**Staff Analysis of Proposed Amendment to the
Dane County Land Use and Transportation Plan, Farmland Preservation Plan and
Water Quality Plan to Revise the
Cross Plains Urban Service Area Boundary and Environmental Corridors**

1. **Applicant:** Village of Cross Plains

Proposal: Amendment to the Cross Plains Urban Service Area

Submittal Date: Village of Cross Plains, May 1998.

Map 1

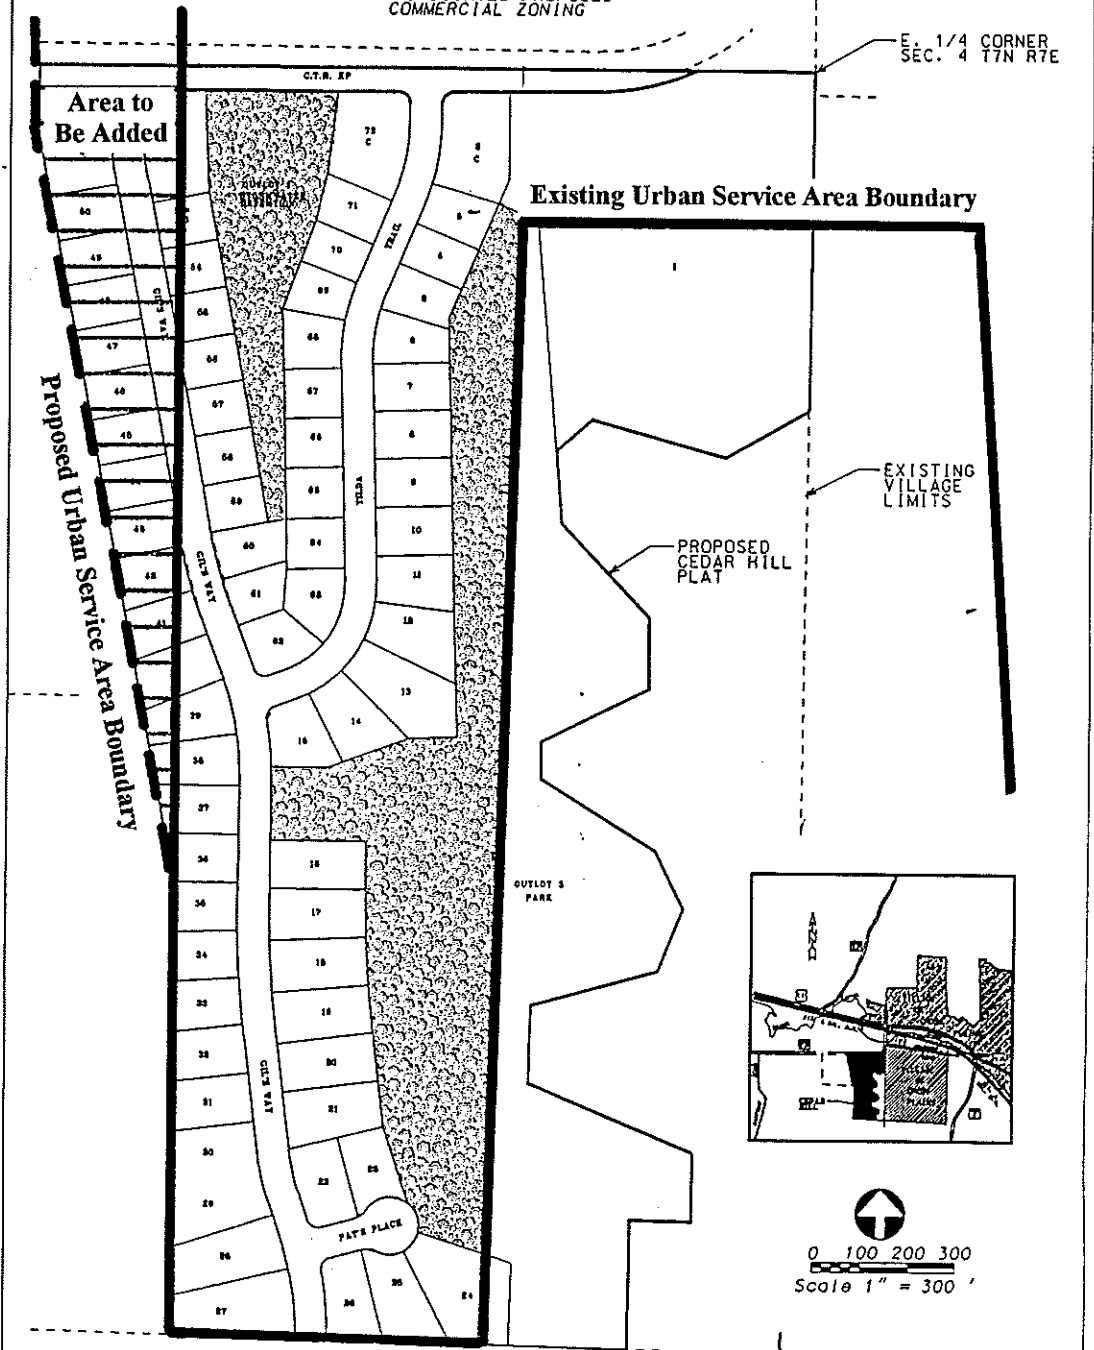
The Village of Cross Plains proposes to add six acres to the Cross Plains Urban Service Area, including 0.2 acre of existing development and 0.8 acre of environmental corridor, as indicated on Map 1. The proposed amendment would also result in the deletion of 1,700 linear feet of environmental corridor within the current urban service area (13.7 acres) and the designation of 1.6 acres of environmental corridors for park purposes. The total net developable acreage change is 17.1 acres. The net reduction in environmental corridors is 11.3 acres. The amendment area is located in the Village of Cross Plains, is zoned R-1 or C for single-family residential or commercial development, and is part of the Cedar Hill Plat (see Map 2). This amendment would allow development of 2 commercial lots and 11 residential lots in the new subdivision.

Environmental Corridors. An 0.8-acre area has been designated as environmental corridor in the addition area to minimize erosion on steep slopes. A total of 12.1 acres of environmental corridors will be deleted in the portion of the proposed development which is currently in the urban service area.

CEDAR HILL, CROSS PLANS - TYPICAL STREET SECTION

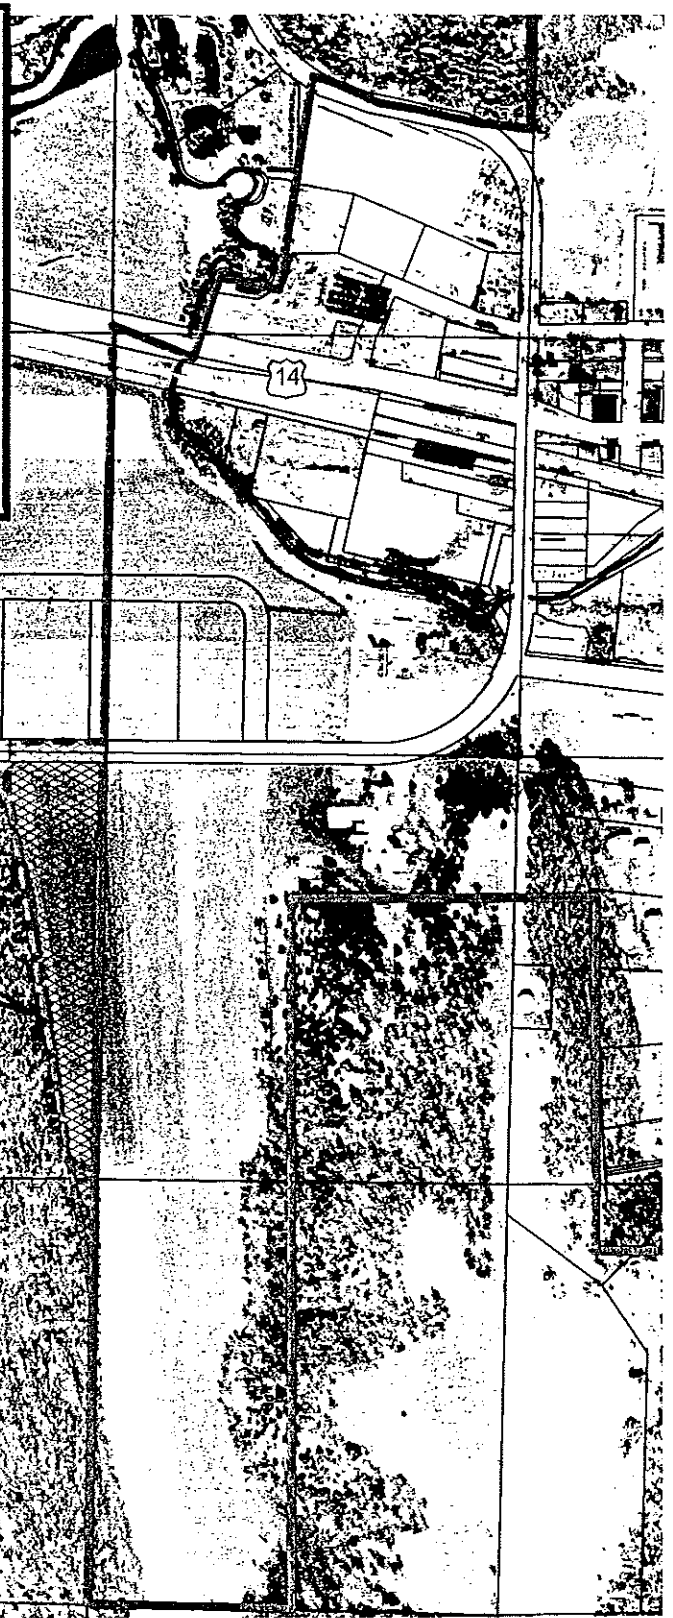
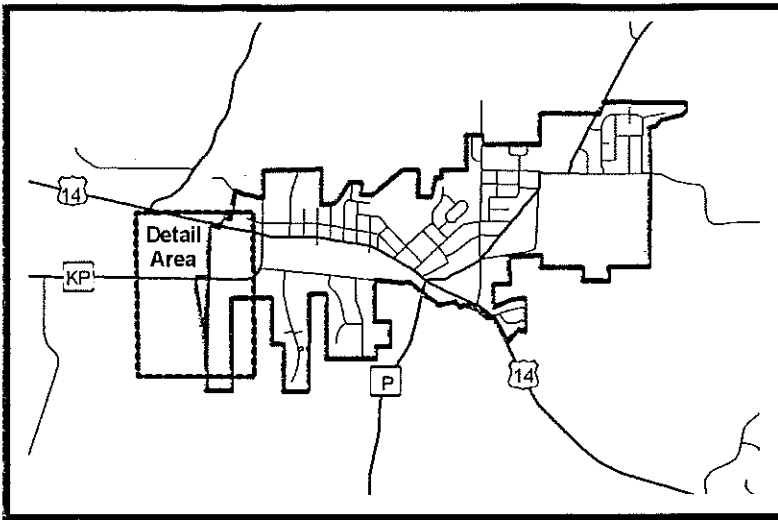
The plan also includes a set of guidelines regarding pedestrian facilities. The plan recommends that sidewalks should be added along both sides of CTH KP, and along one side of Gil's Way. An illustration of a typical street section in the Cedar Hill plat that was submitted with the amendment request shows a sidewalk along one side of the street.
